ADDENDUM NO. 2
TO THE CONTRACT DOCUMENTS
for the construction of
TRANSITION PARKWAY AND
LINEAR PARK PROJECT

Date: June 20, 2024
City Project No.: 2022-006

The following changes, additions, and/or deletions are hereby made a part of the Contract Documents for the construction of Transition Parkway and Linear Park dated May 2024 as fully and completely as if the same were fully set forth therein:

EQUIPMENT PAD

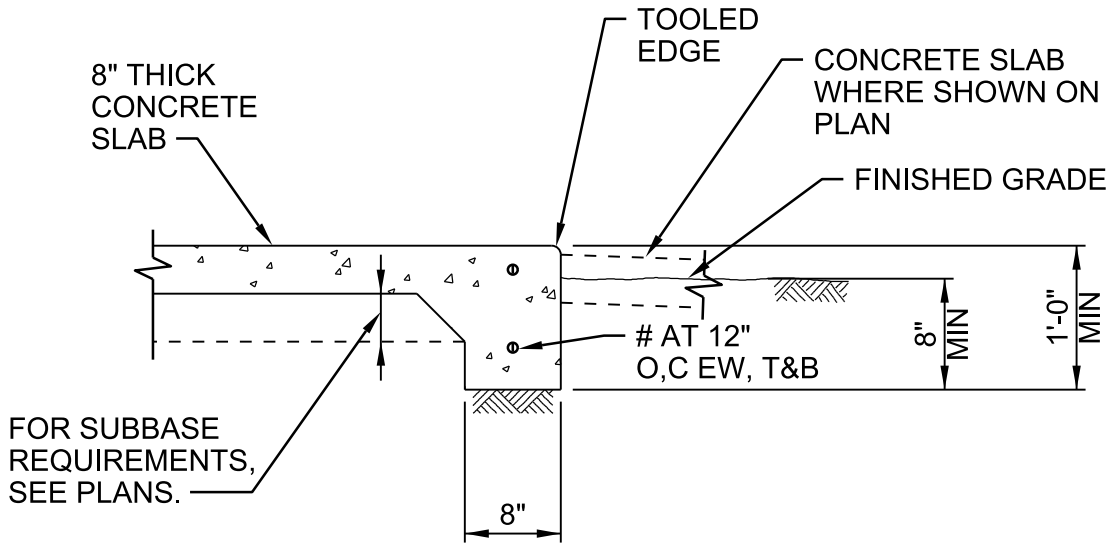
- A. ADD the attached to Volume 3, Standard Details, Detail 0330-210, Equipment Pad.
